Office Action Summary

09/851,970

UMEMOTO ET AL.

DETAILED ACTION

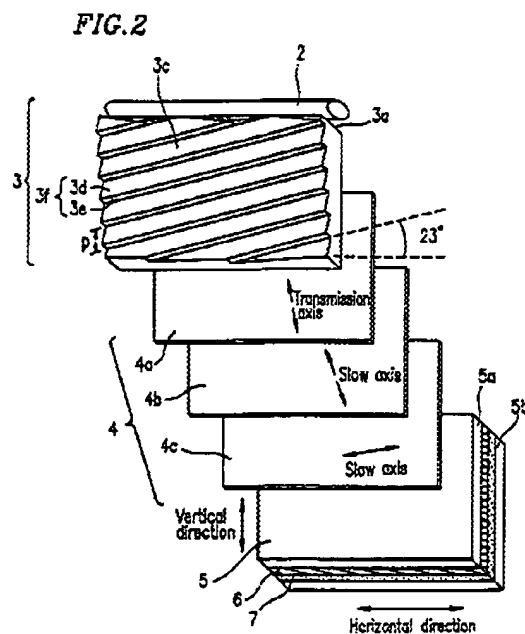
As to claim 1, Masuda discloses in Embodiment 3, Figure 10, (col. 15, line 25 through col. 18, line 16) a reflection type liquid-crystal display device comprising: a reflection type liquid-crystal display panel, 5, including a liquid-crystal cell and a reflector, 7, said liquid-crystal cell having a visual-side substrate, a back-side substrate, 5b, and a liquid crystal, 6, said visual-side substrate including a light guide, 3 (Applicant's transparent substrate), a low-refractive resin layer, 10a (Applicant's transparent layer), lower in reflective index (1.38, col. 15, lines 35-39) than the transparent substrate (1.49, col. 15, lines 35-39), and a transparent electrode (not shown), said back-side substrate having an electrode (not shown), said liquid crystal being held between said visual-side and back-side substrates so that respective electrode sides of said visual-side and back-side substrates are disposed opposite to each other, said reflector being disposed on the back-side substrate side (per Figure 10);

an optical path control layer having a repetitive structure of optical path changing slopes, 3c, on an outer side of said visual-side substrate and being higher in refractive index (1.49, col. 15, lines 35-39) than said low-refractive-index transparent layer, each of said optical path changing slopes being inclined at an inclination angle in a range of from 35 to 48 degrees with respect to a reference plane of said visual-side substrate as graphically illustrated by the light path arrow in the upper portion of Figure 10 below.

Masuda does not explicitly disclose and Applicant does not explicitly claim an optical path control layer having a repetitive structure of optical path changing slopes, on an outer side of said visual-side substrate that is not integral to the transparent substrate. However, making integral or making separable the parts of the visual-side substrate are species not considered patentably distinct. It would have been obvious to one having ordinary skill in the art at the time the invention was made to comprise the claimed structure of the visual-side substrate as an art-recognized species suitable for the intended purpose of forming a transparent substrate (MPEP 2144.07).

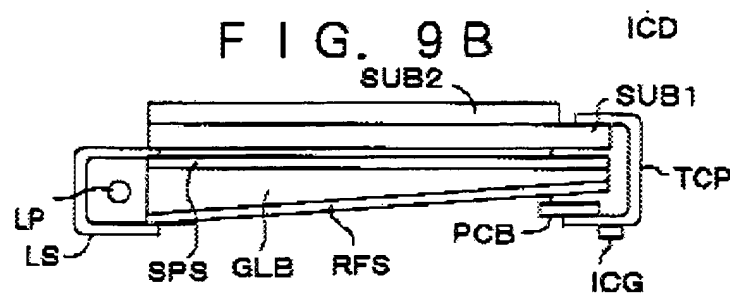
Masuda does not explicitly disclose a device wherein: at least one side surface of said visual-side substrate is protruded outward from that of said back-side substrate; and each illuminator is disposed on said protruded side surface of said visual-side substrate, and wherein each illuminator is disposed and held on said side surface of said visual-side substrate in such a manner that said illuminator is enclosed by a reflection type light source holder and end portions of said light source holder are bonded to end portions of upper and lower surfaces of said visual-side substrate.

Nemoto teaches in Figure 9B the use of a protruded side surface with a light source holder, LS, bonded to end portions of upper and lower surfaces of transparent substrate, GLB, to comprise a lighted display assembly (col. 7, lines 27-32).
